MFN 06-429

Subject: **Response to Portion of NRC Request for Additional Information
Letter No. 59 Related to ESBWR Design Certification Application –
ESBWR Probabilistic Risk Assessment and Chapter 19 - RAI
Numbers 19.5-3 through 19.5-14**

**Response to Portion of NRC Request for
Additional Information Letter No. 59
Related to ESBWR Design Certification Application
ESBWR Probabilistic Risk Assessment and Chapter 19
RAI Numbers 19.5-3 through 19.5-14**

Figure 19.5-13 (1) Comparison of Design Ground Spectrum with Soil and Rock Spectra

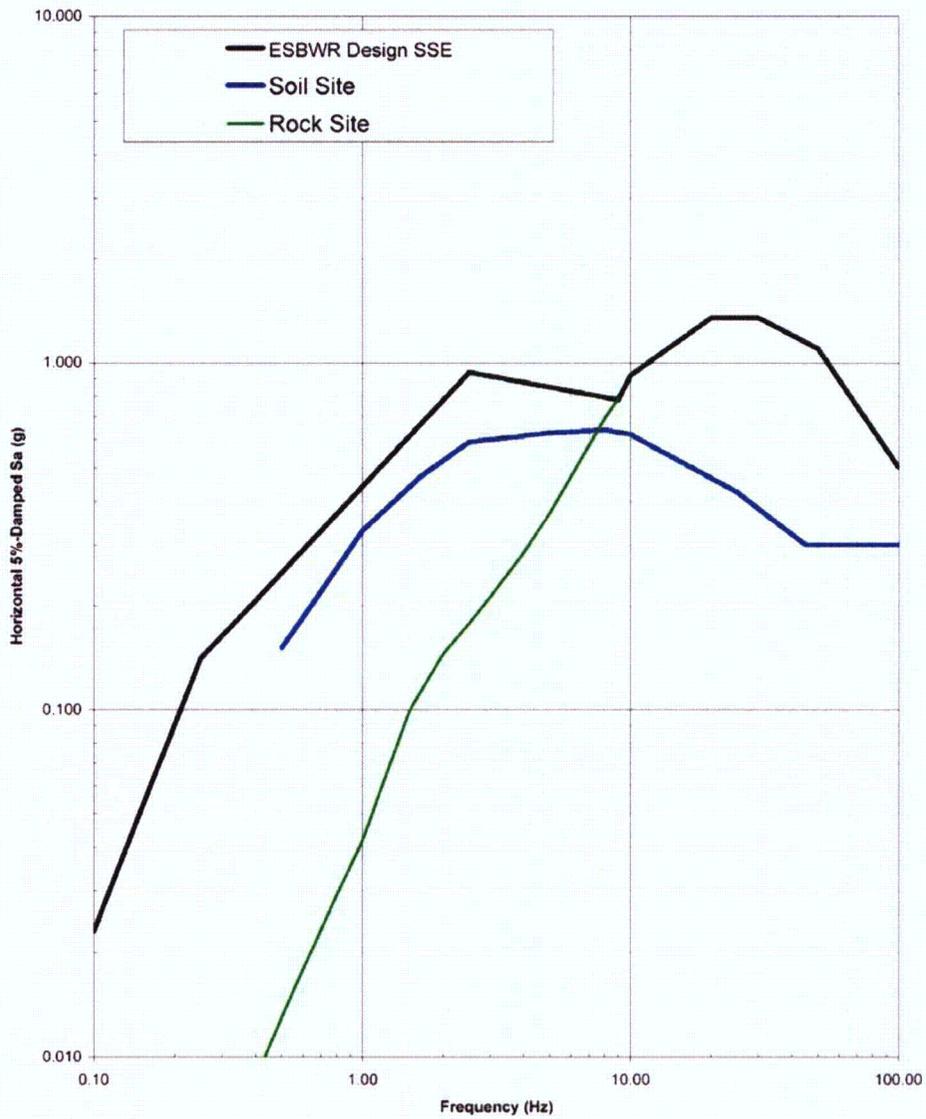
For the shape factor (Fsa), Section 15.3.3.1.2 of NEDO-33201, Rev. 1, states that for the purpose of seismic risk assessment, the median ground motion spectrum given in NUREG/CR-0098, "Development of Criteria for Seismic Review of Selected Nuclear Power Plants," is considered to be the realistic input ground motion definition. Considering the significant number of advancements in the field of seismic hazards since the development of this spectrum in the late 1970's, justify your consideration of the NUREG/CR-0098 spectrum as realistic input ground motion.

The shape factor will be re-evaluated for two site conditions, rock and soil.

For rock sites, the North-Anna site SSE spectrum will be compared to the ESBWR single envelope design spectrum to determine the shape factor.

For soil sites, the bounding SSE spectrum of soil sites among the 28 sites (excluding Vogtle) included in the current EPRI study will be compared to the ESBWR single envelope design spectrum to determine the shape factor. See Figure 19.5-13 (1) for spectrum comparison.
